PROPOSED SECTION BB

revisions
P1 - Planning Issue - 08.09.15

drawing	PROPOSED SECTION BB	scale @ A1
status	checked by IL	date drawn 01.10.2015
project reference	drawing number	revision
131128 - 810	21-822	P1

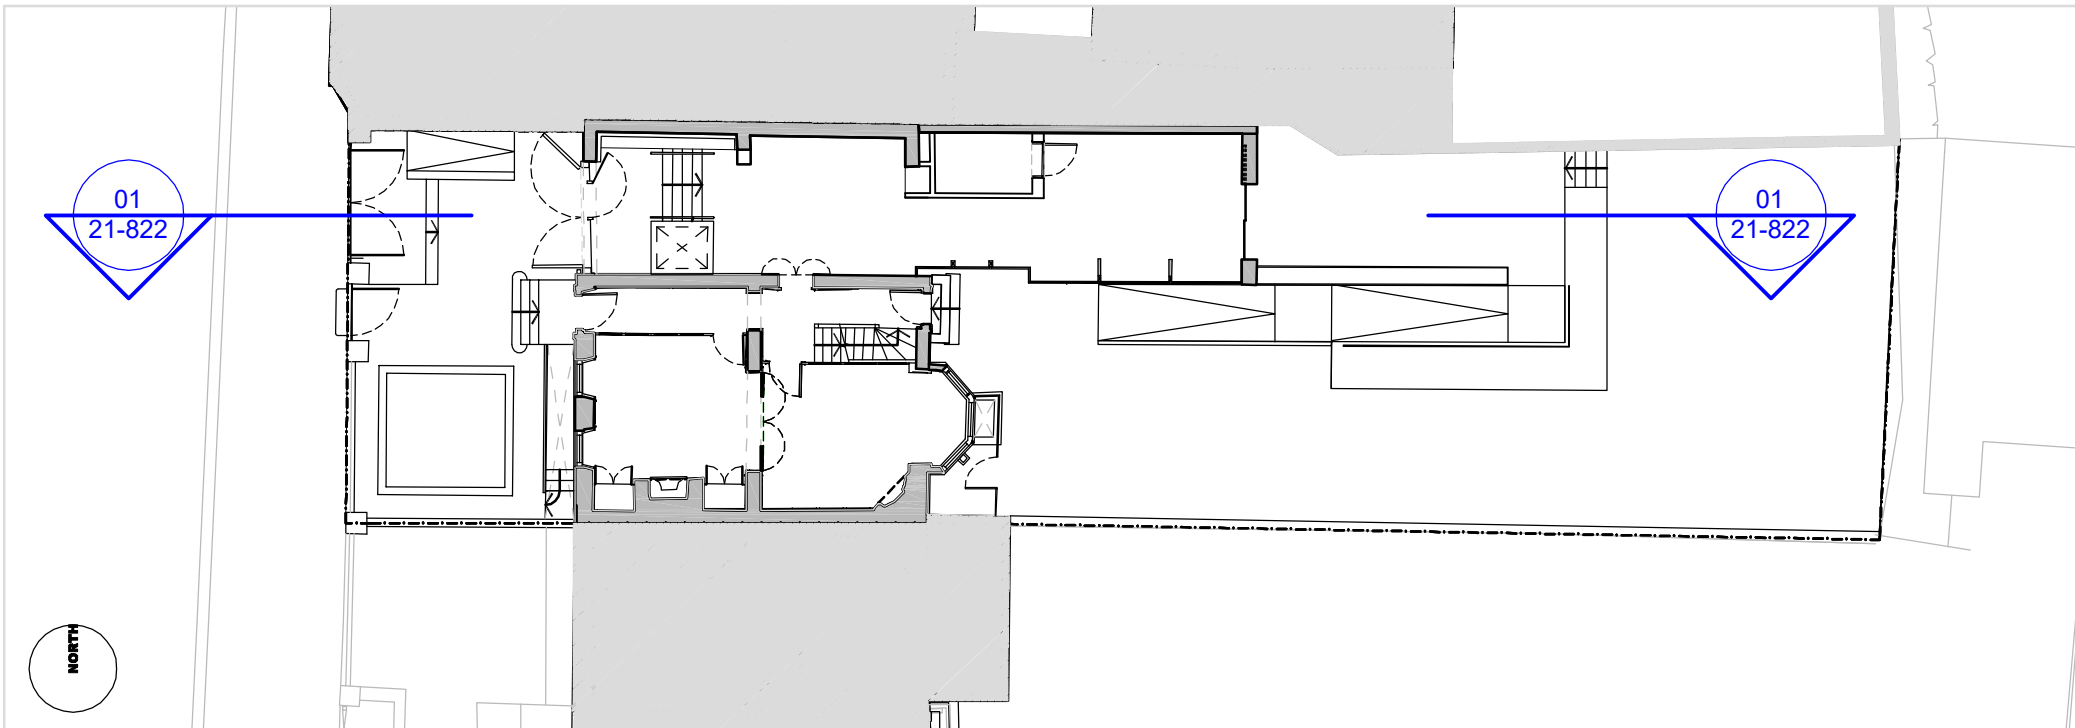
1. Existing floor level retained, steps and platform lift omitted – rear addition façade extended down to ground level.
2. Consented single storey rear addition extended by 1.5m, to the east.
3. Junction between existing building and rear extension altered with addition of glazed link – associated roof geometry altered.
4. Landscaping revised to suit café extension at grade level.
